Addendum

Florida Gateway College
New Building 102 – STEM Two
FGC ITB # ST-24-01-06
Lake City, Florida

02

May 14, 2024

TYPICAL AHU INSTALLATION NTS 6

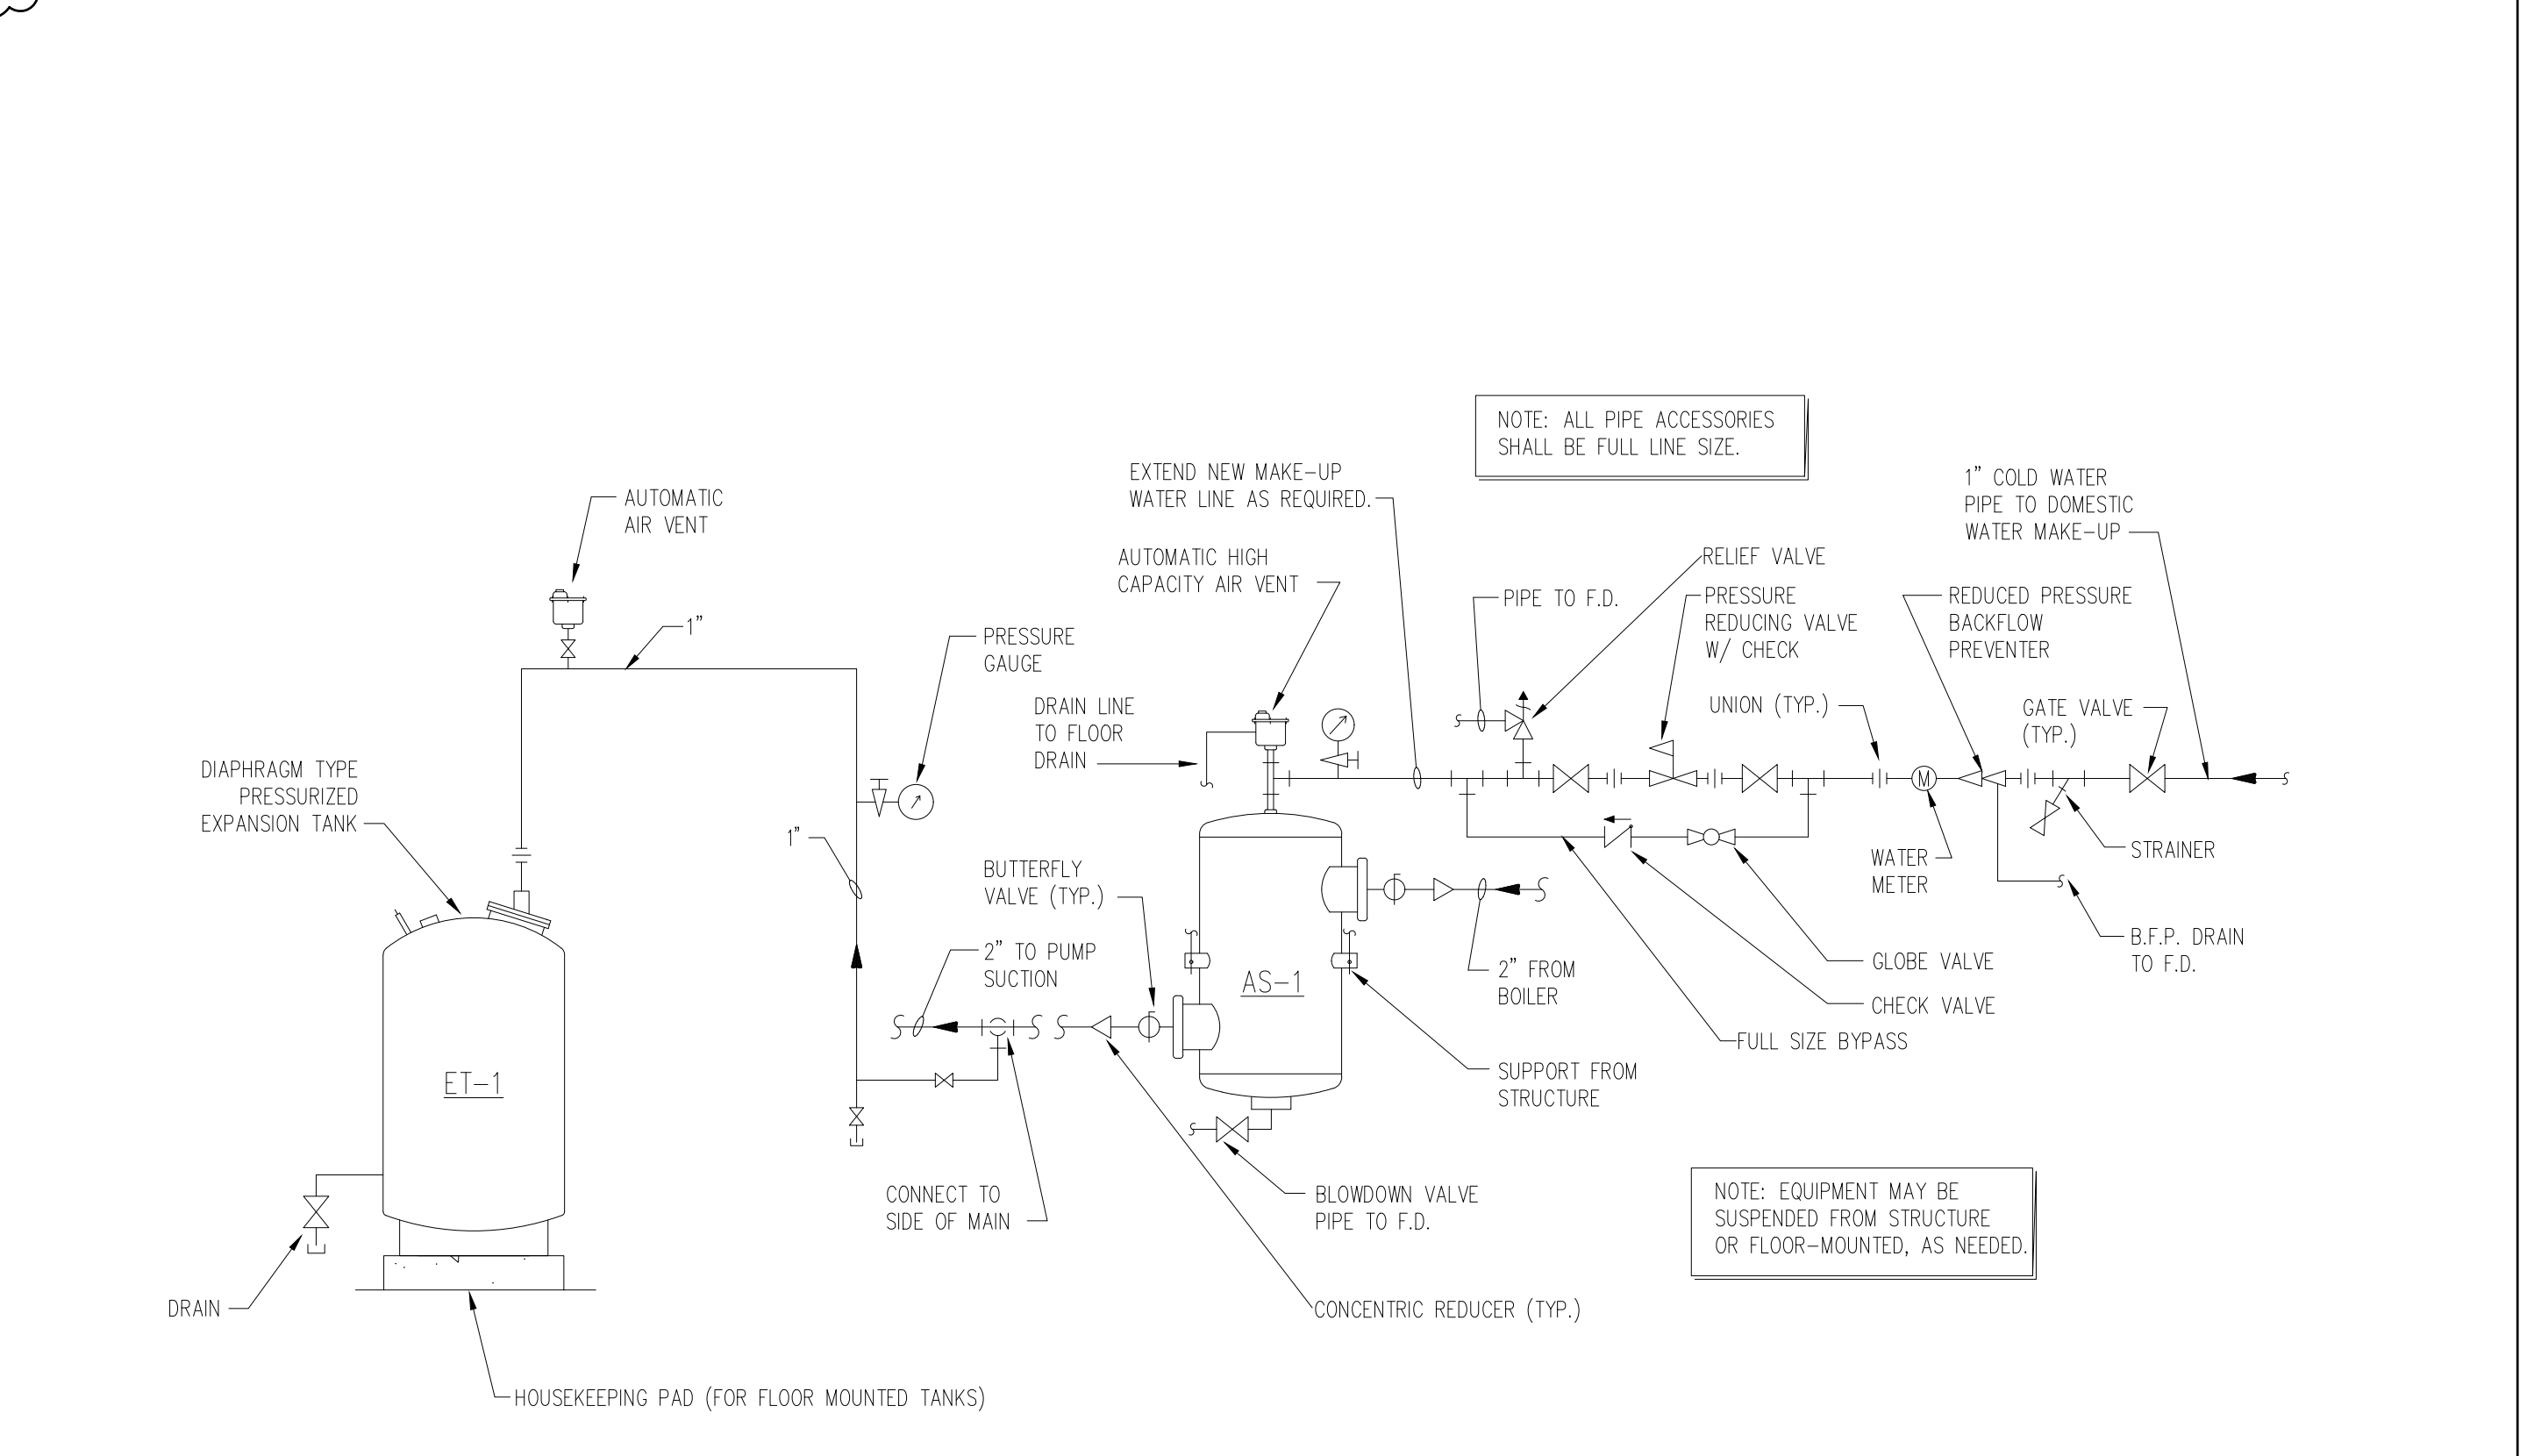
23. **DRAWINGS, SHEET M302 – HVAC DETAILS:** Refer to the attached reissued Sheet. AHU connection detail added to Drawing.
24. **DRAWINGS, MECHANICAL - GENERAL:** For clarification, a pre-bid RFI asked: "We need to know what underground system they are wanting, whether it be a carbon steel pipe in a HDPE jacket with foam around it? How deep the pipe needs to be? What pressure test needs to be done after completion?" and the response is: "Refer to specification Section 23 2113 – Hydronic Piping for HVAC piping and pressure requirements. Site piping needs to be installed a minimum of 3'-0" below finished grade. It is acceptable to match the pipe material of the existing chilled water main and provide with an HDPE jacket."

1 ELECTRICAL SITE PLAN
SCALE: 1" = 10'

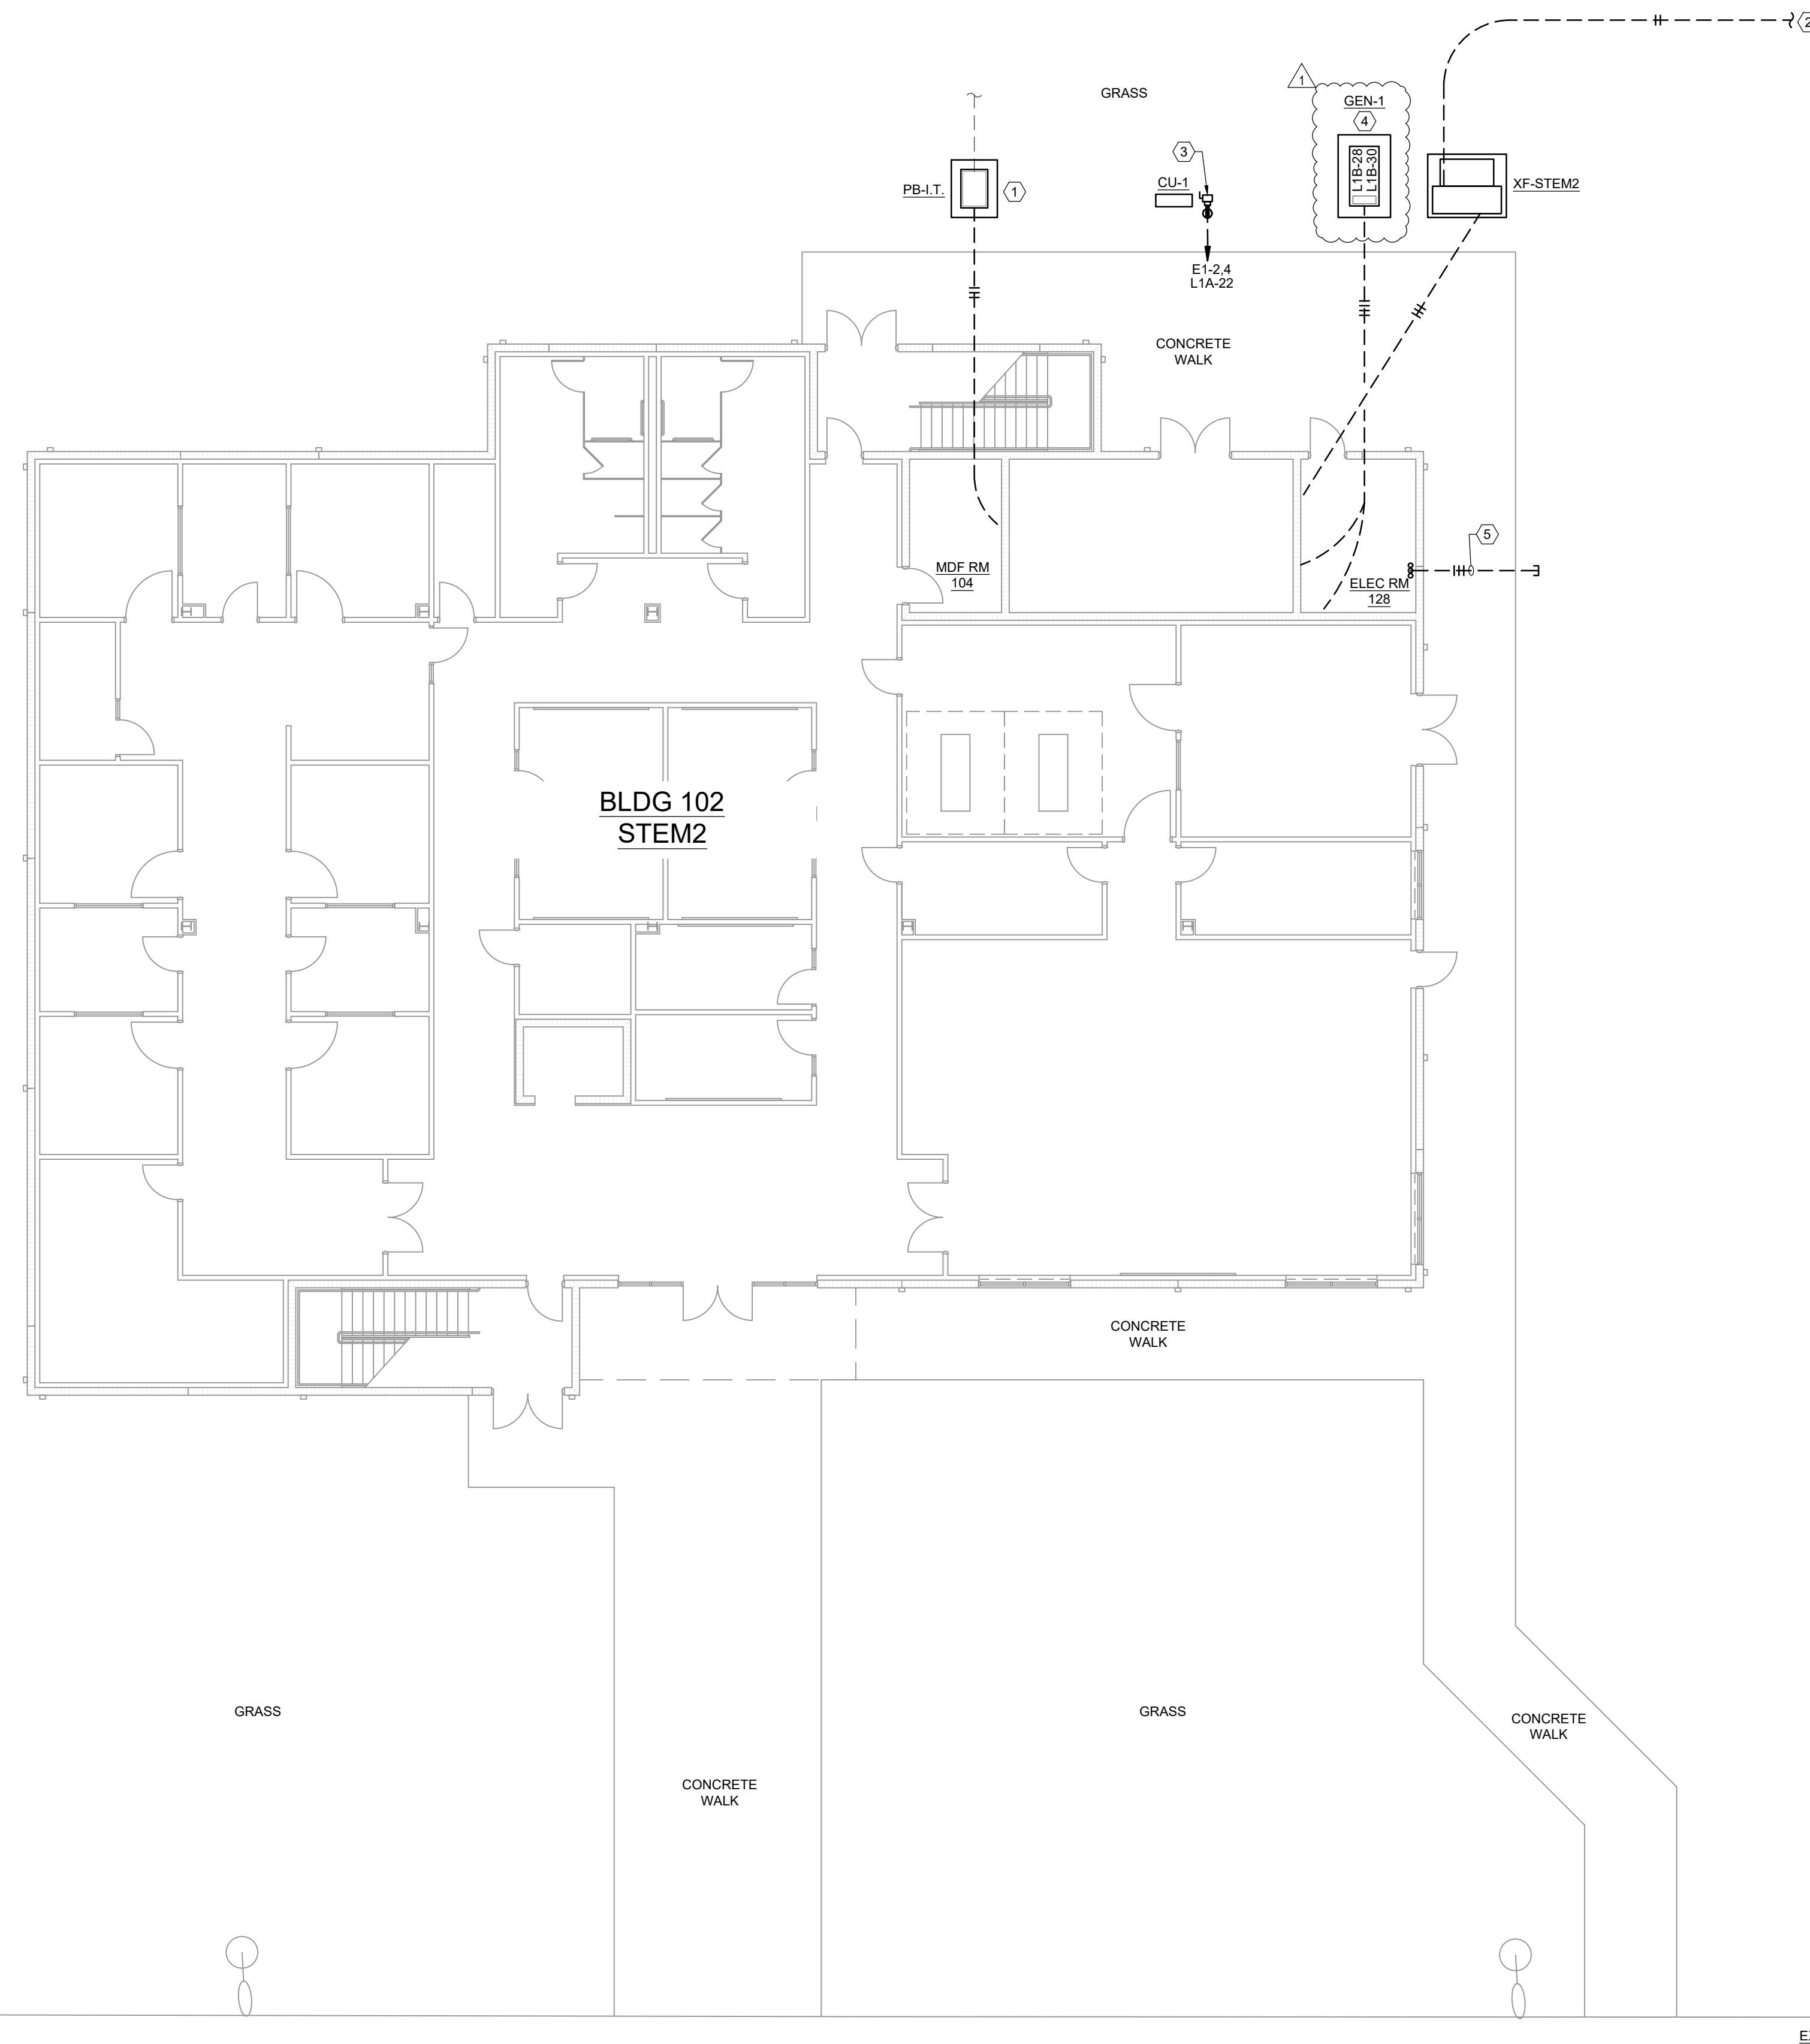
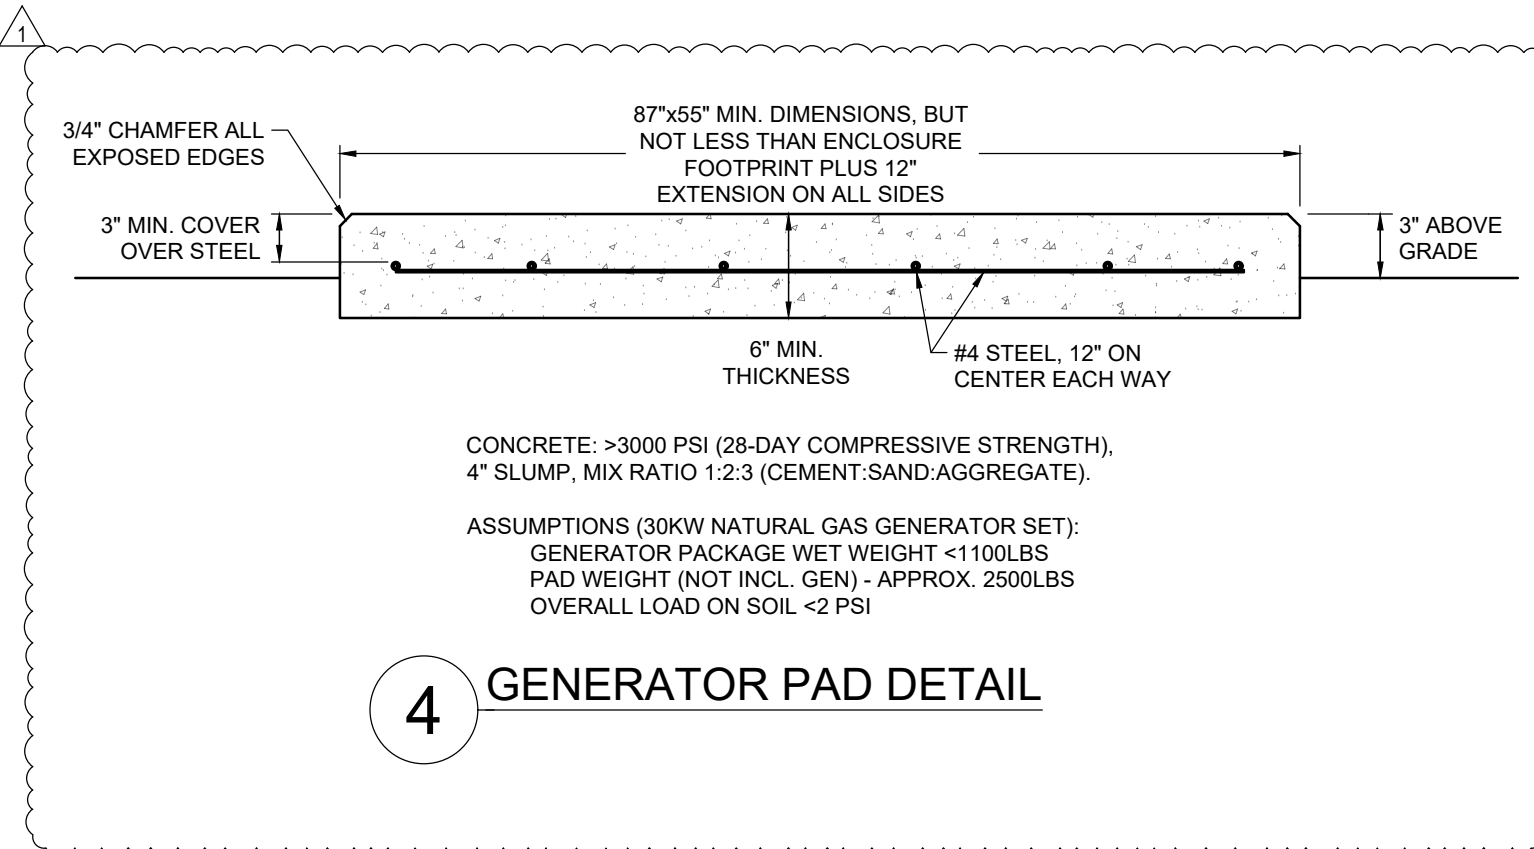
26. **DRAWINGS, SHEET E101 – ELECTRICAL SITE PLAN:** Refer to the attached reissued Sheets. Generator pad dimensions were changed and the reference to "diesel" generator was replaced with "natural gas".
